ENGINE FUEL AND CONTROL - TRANSMITTAL OF SHADIN SB05-19-001 FUEL FLOW TRANSDUCER 680501K & 680501J LOCKWASHER INSTALLATION

SEL-73-09
Page 1 of 2

SB05-19-001

FUEL FLOW TRANSDUCER 680501K & 680501J LOCKWASHER INSTALLATION

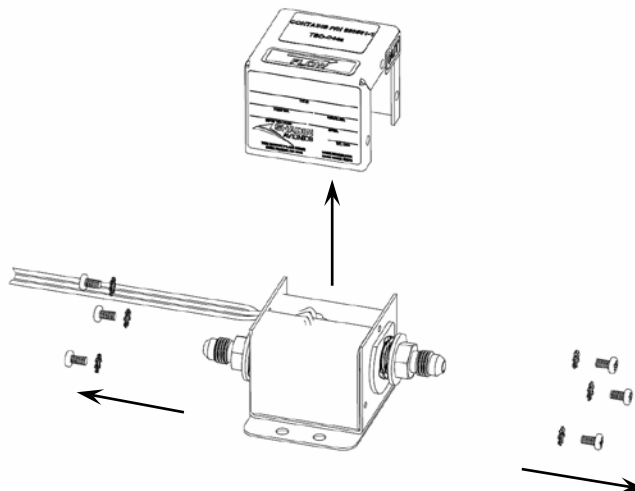
- For disassembly of the cover, remove 6 screws.
- Lift the cover off and peel back the fiberglass insulation.

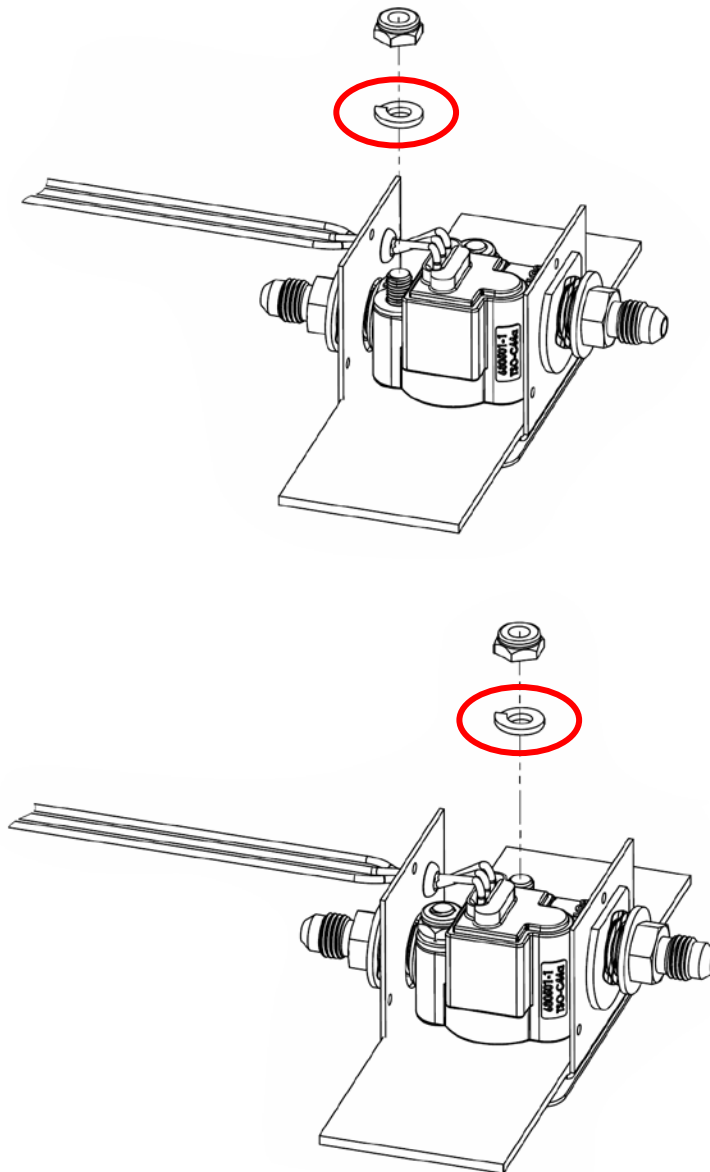
- Remove locknut and add lock-washer for one bolt (MS P/N: MS35338-44). Only have one locknut loosened at a time.

- D. While holding one end of the bolt / locknut stationary with the open-end wrench, torque to 10-11 Ft-Lbs.
- E. Repeat steps C and D for the other locknut and bolt.
- F. Fold the insulation over the transducer.
- G. Apply the cover to the enclosure.
- H. Install screws to 5-6.5 In-Lbs.
